**CONTRACT I-20-4517**

**ROADWAY AND BRIDGE RECONSTRUCTION  
TRI-STATE TOLLWAY (I-294)**

**ADDENDUM NO. 2  
TO  
CONTRACT REQUIREMENTS  
FOR CONTRACT I-20-4517  
ILLINOIS STATE TOLL HIGHWAY AUTHORITY**

**Date: 7/28/2020**

CONTRACT NO. I-20-4517  
 PROPOSED TYPICAL SECTIONS  
 TYP-09  
 DRAWING NO. 49 OF 1762

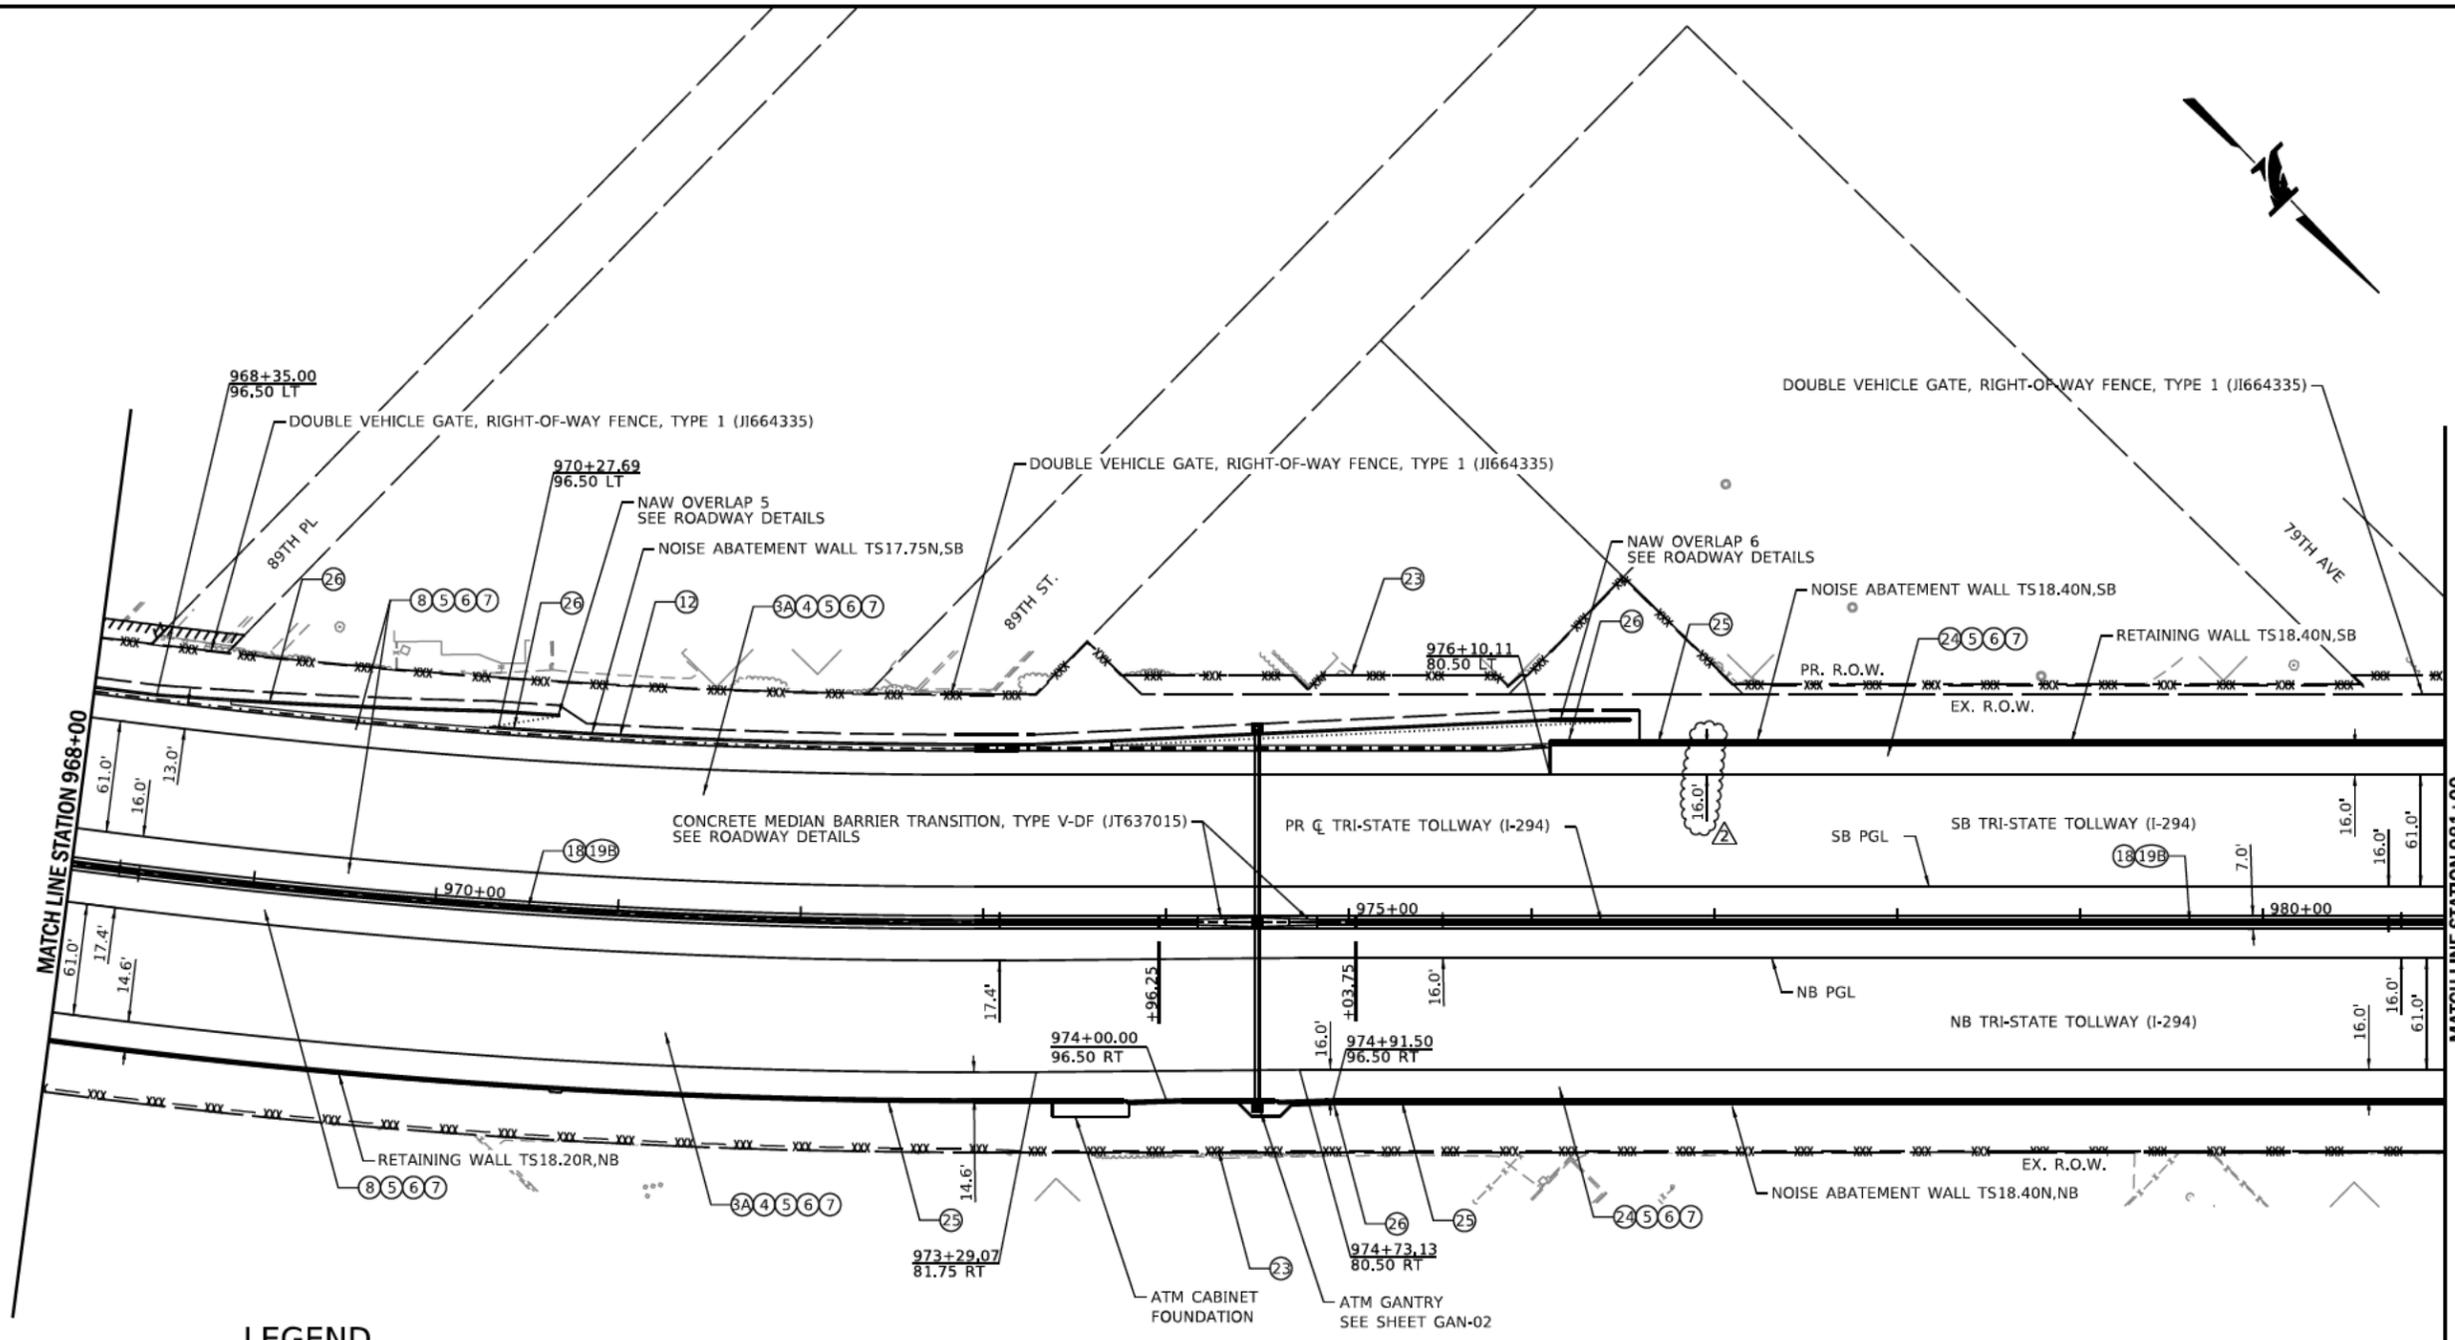
**Change #5** Contract Plans, Volume 1, Drawing 49. Proposed Typical Sections. This drawing contains the following revision (attached):

- 5.1. Revised shoulder slope on moment slab.

CONTRACT NO. I-20-4517 RDY-04  
 ROADWAY PLANS DRAWING NO. 171 OF 1762  
 STA. 968+00 - STA. 981+00

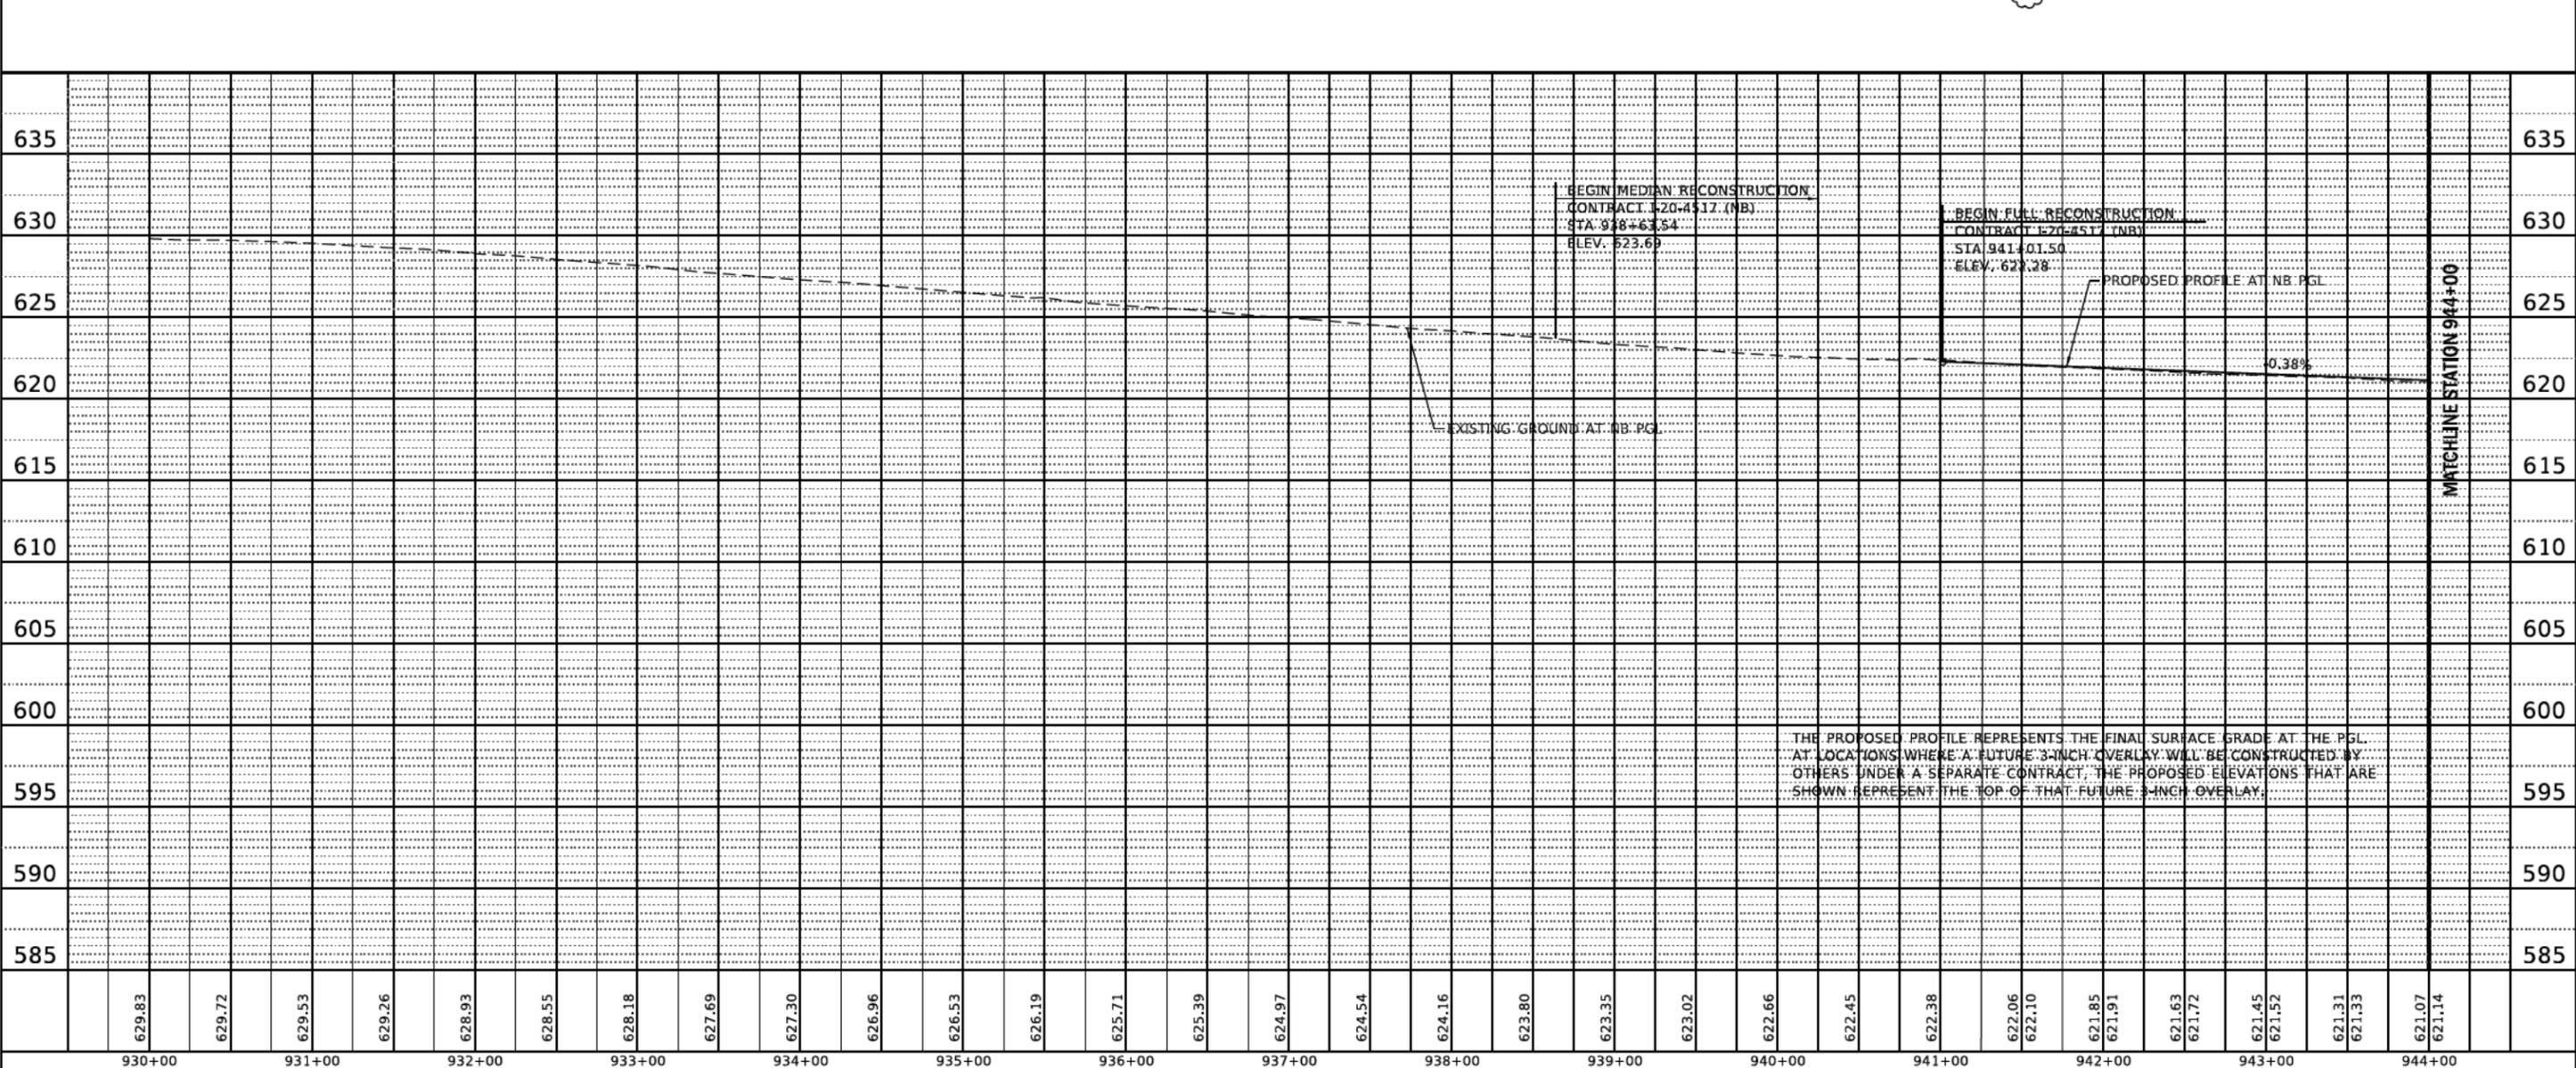
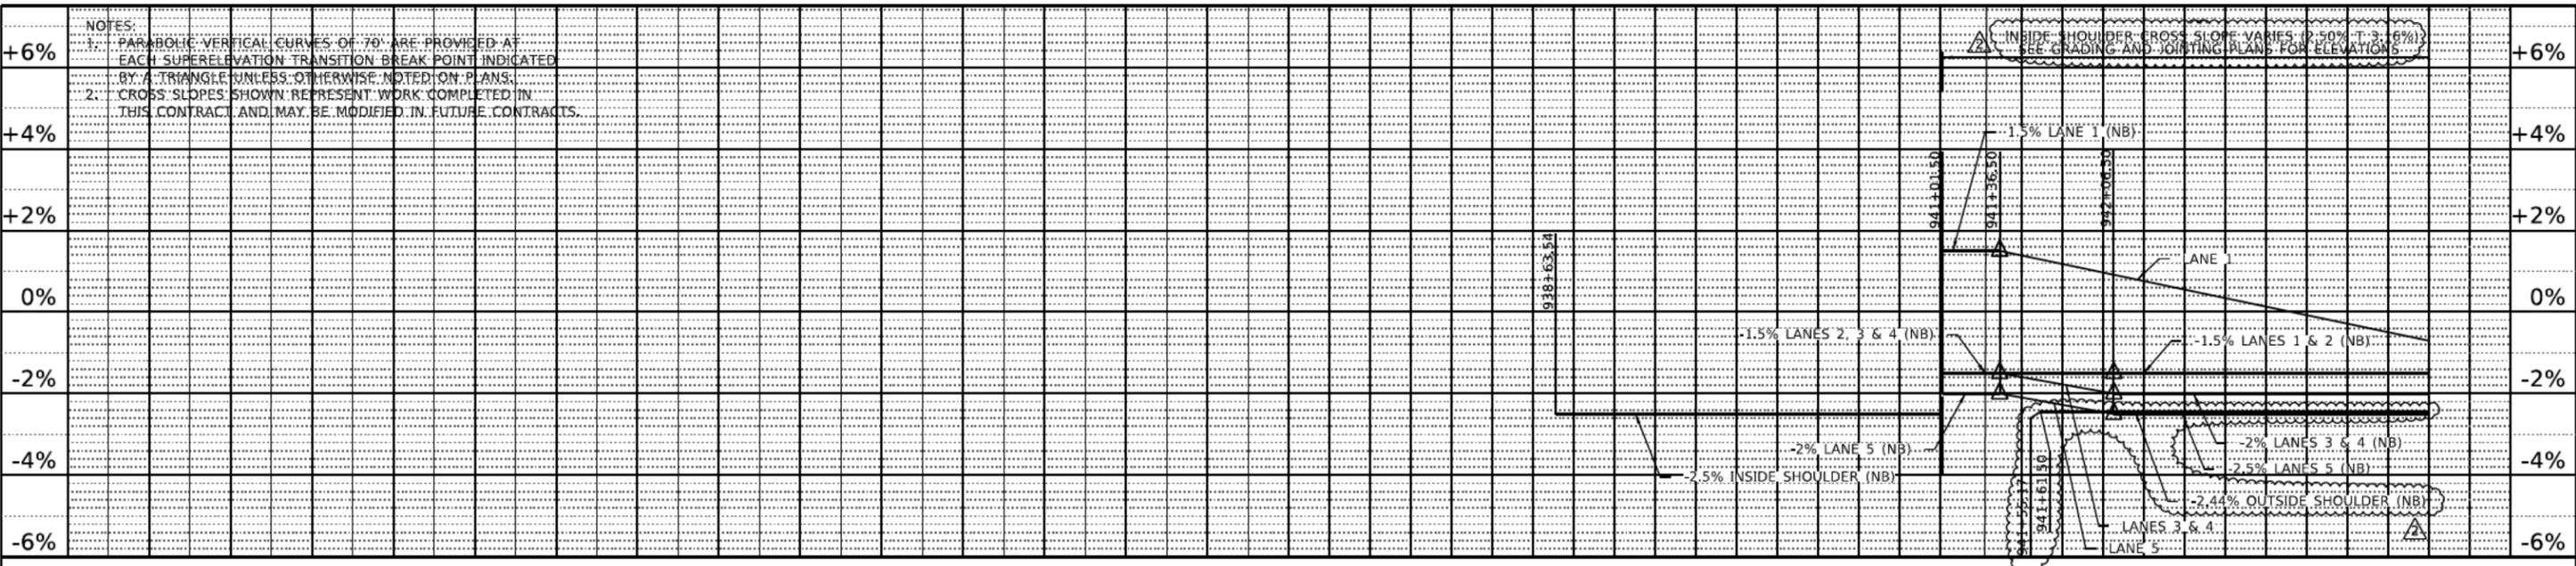
**Change #6** Contract Plans, Volume 1, Drawing 171. Roadway Plans. This drawing contains the following revision (attached):
